Subject: AP1000 COL Response to Request for Additional Information (TR 29)

Westinghouse is submitting a revised response to the NRC request for additional information (RAI) on AP1000 Standard Combined License Technical Report (TR) 29, APP-GW-GLR-044, Nuclear Island Basemat and Foundation. This RAI response is submitted in support of the AP1000 Design Certification Amendment Application (Docket No. 52-006). The information included in the response is generic and is expected to apply to all COL applications referencing the AP1000 Design Certification and the AP1000 Design Certification Amendment Application.

RAI Response Number: RAI-TR29-SRSB-01
Revision: 1

Figure 2-7
Turbine Trip
(Minimum DNBR Case)

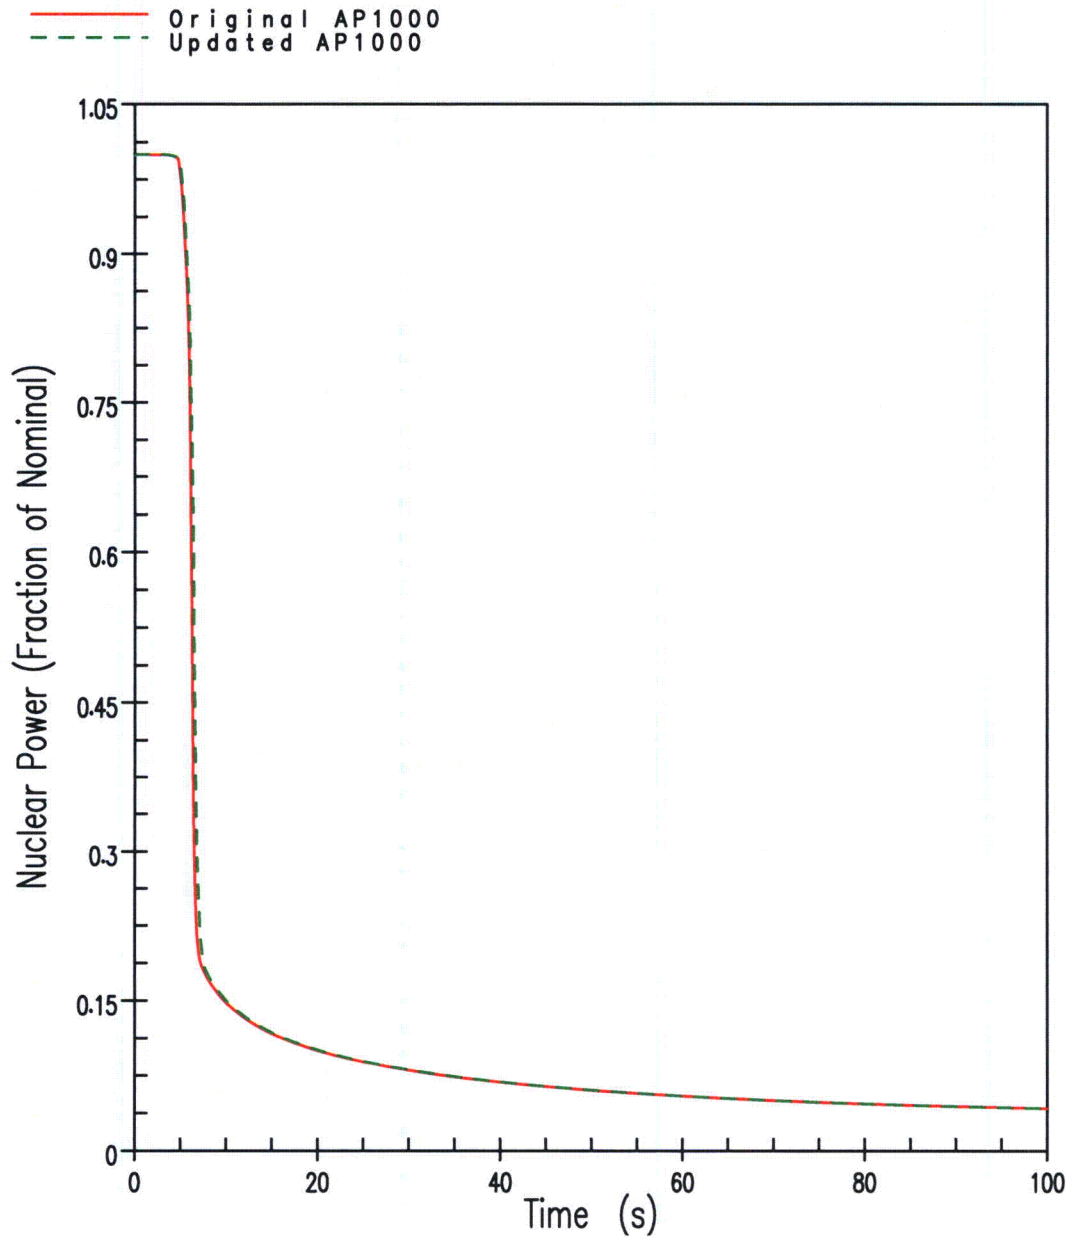
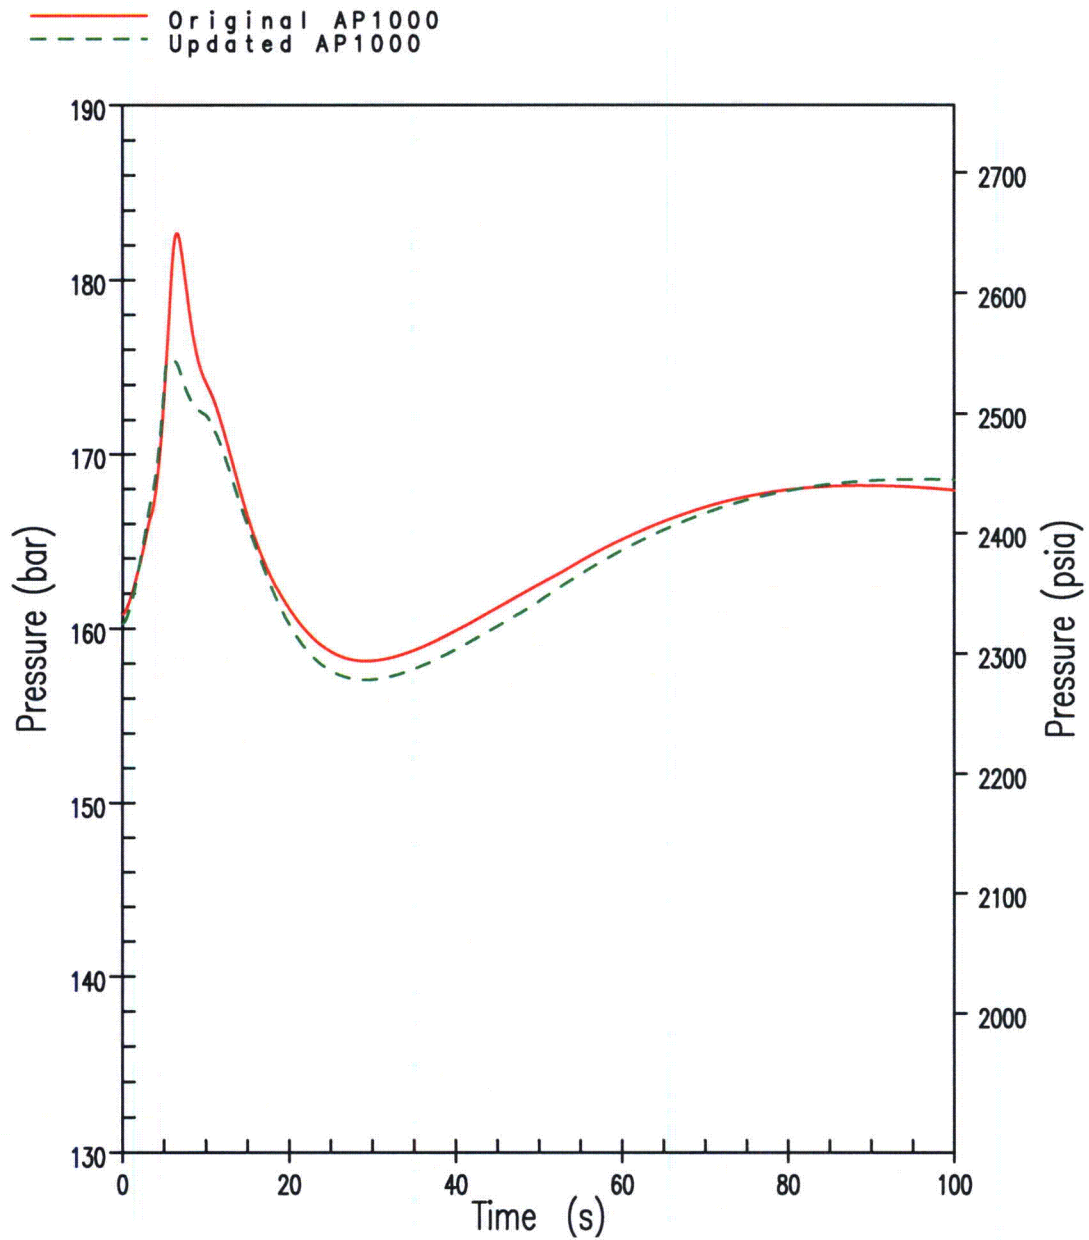
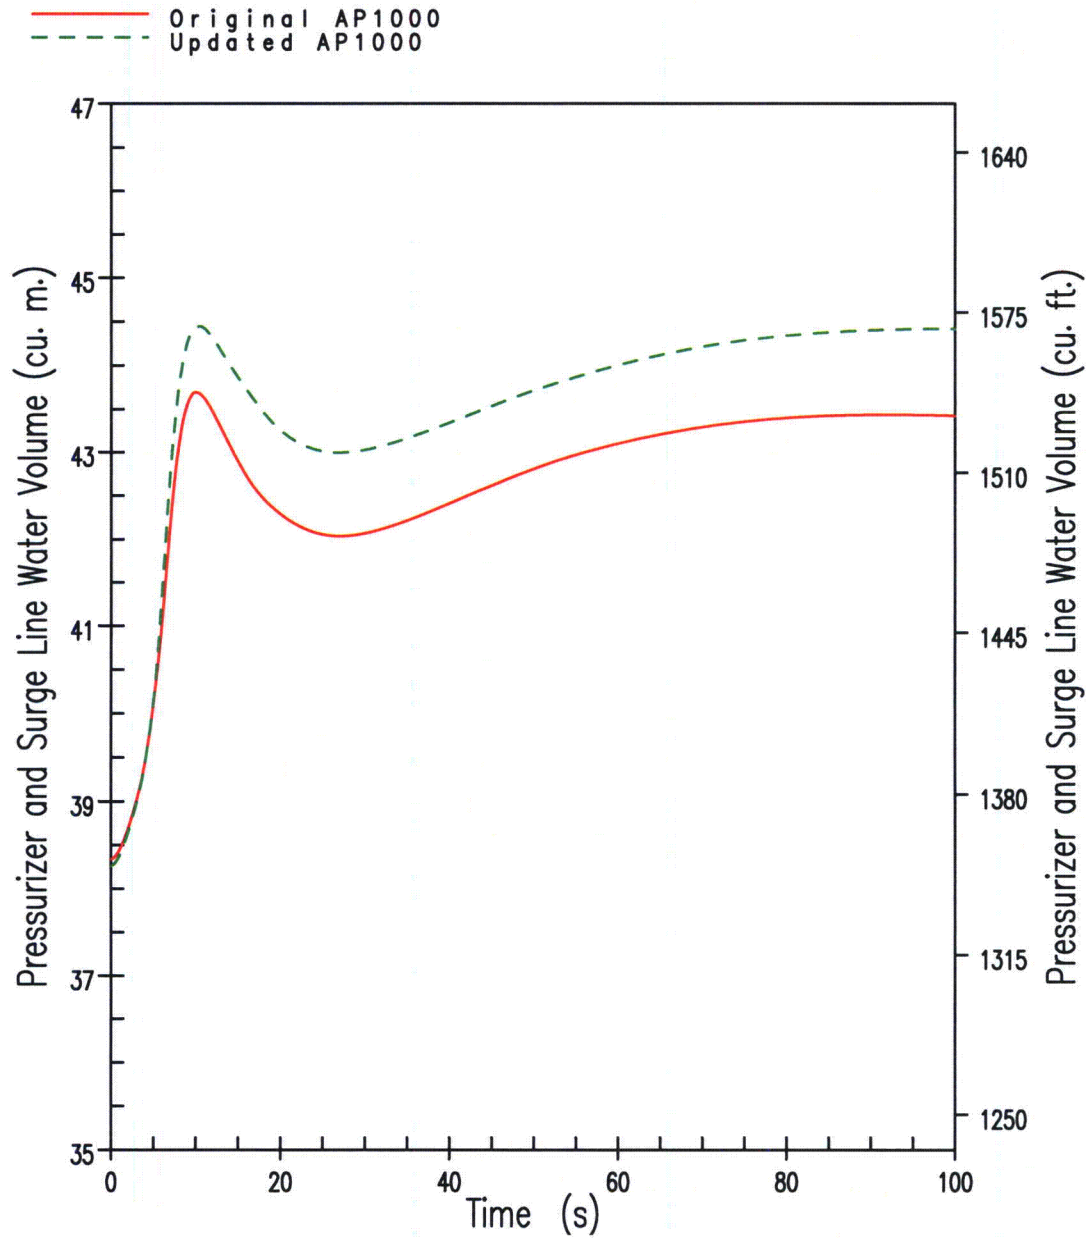
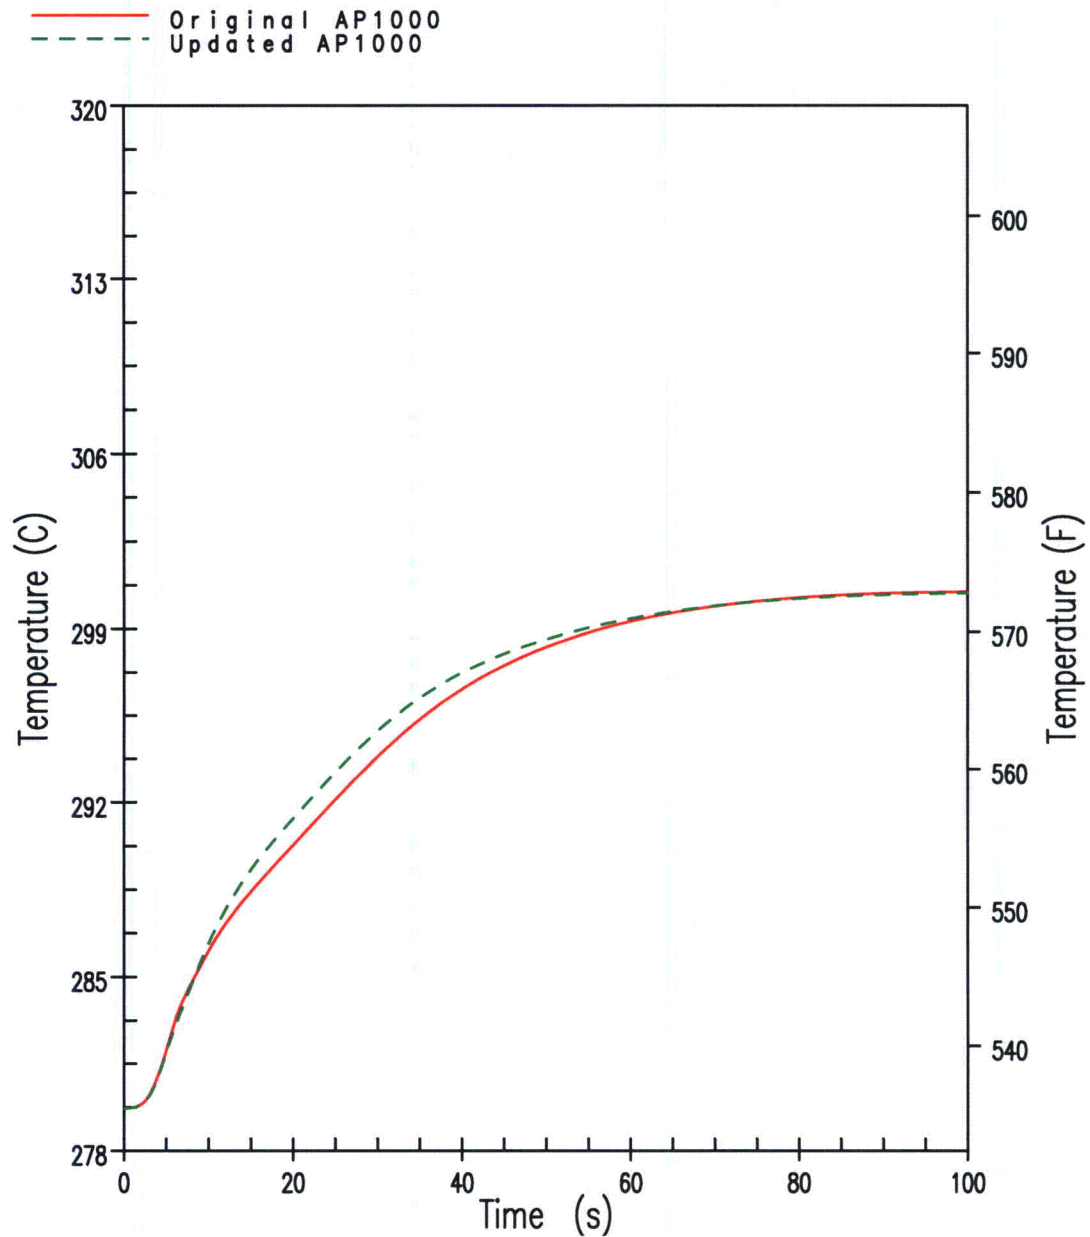
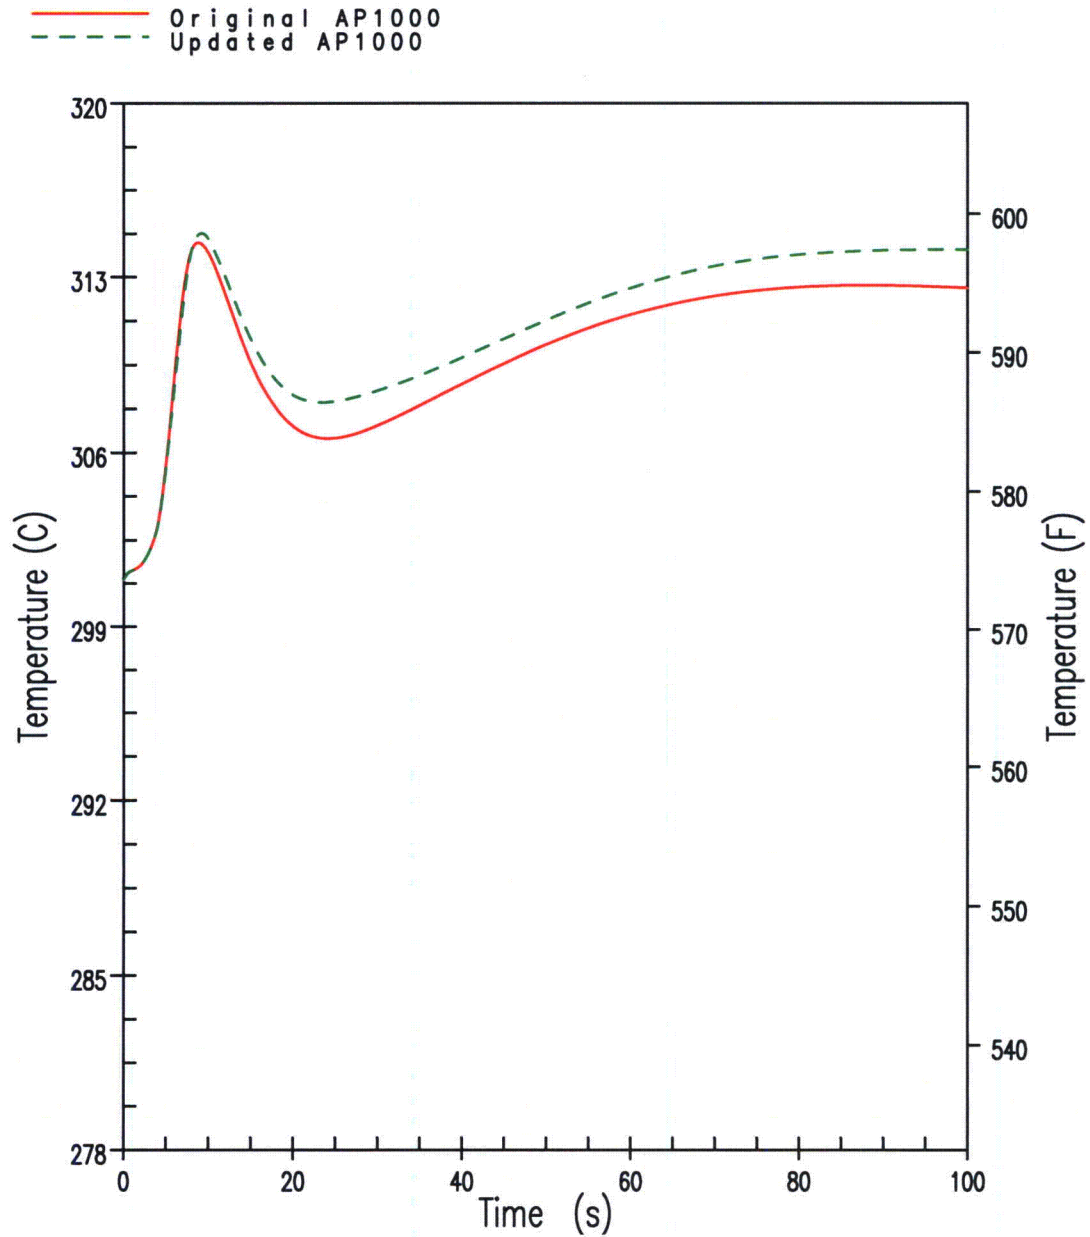
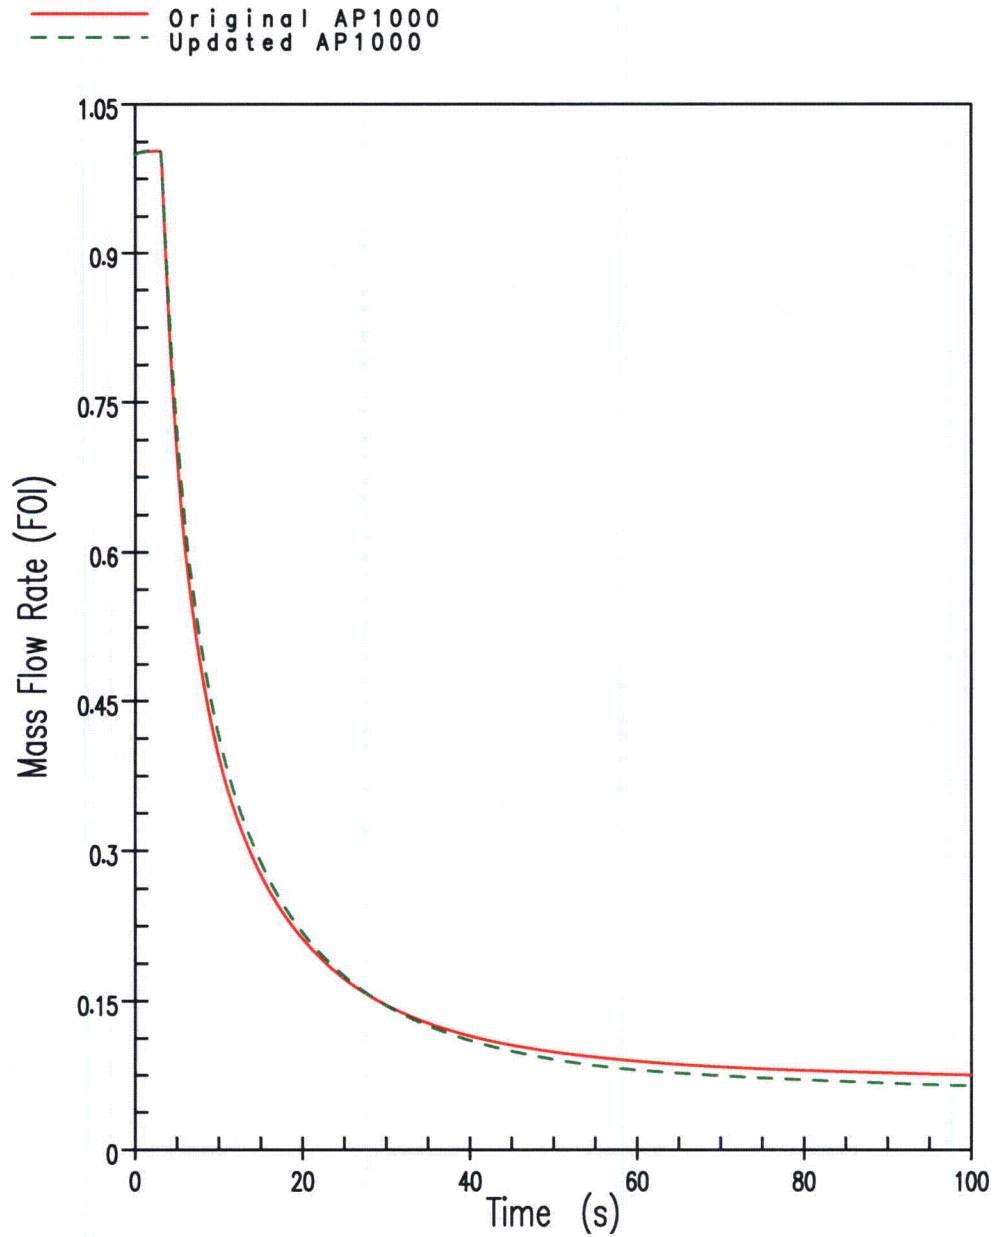
Please provide an evaluation of the impacts of these proposed changes on the analysis results of each of the transients and accidents in DCD Chapter 15. The evaluation should demonstrate either the analysis results of DCD Chapter 15, Revision 15, remain bounding and valid, or the effects of these changes are insignificantly small that the applicable acceptance criteria for these transients and accidents remain complied with.

The most limiting case with respect to minimizing the core DNB ratio is the case with the pressurizer pressure control system available, with minimum reactivity feedback, and without offsite power available. Results for the limiting DNB ratio case are shown in Figures 2-7 through 2-12. A sequence of events is provided in Table 2-1 and is identified as Case A.2. The minimum DNB ratio for the updated AP1000 is 1.58 as compared to a value of 1.57 for the original AP1000 plant configuration. The analyses show that the predicted DNBR is greater than the safety analysis limit of 1.5 at all times during the transient. Thus, the departure from nucleate boiling design basis continues to be met, and the existing turbine trip analysis remains applicable for the new AP1000 configuration.
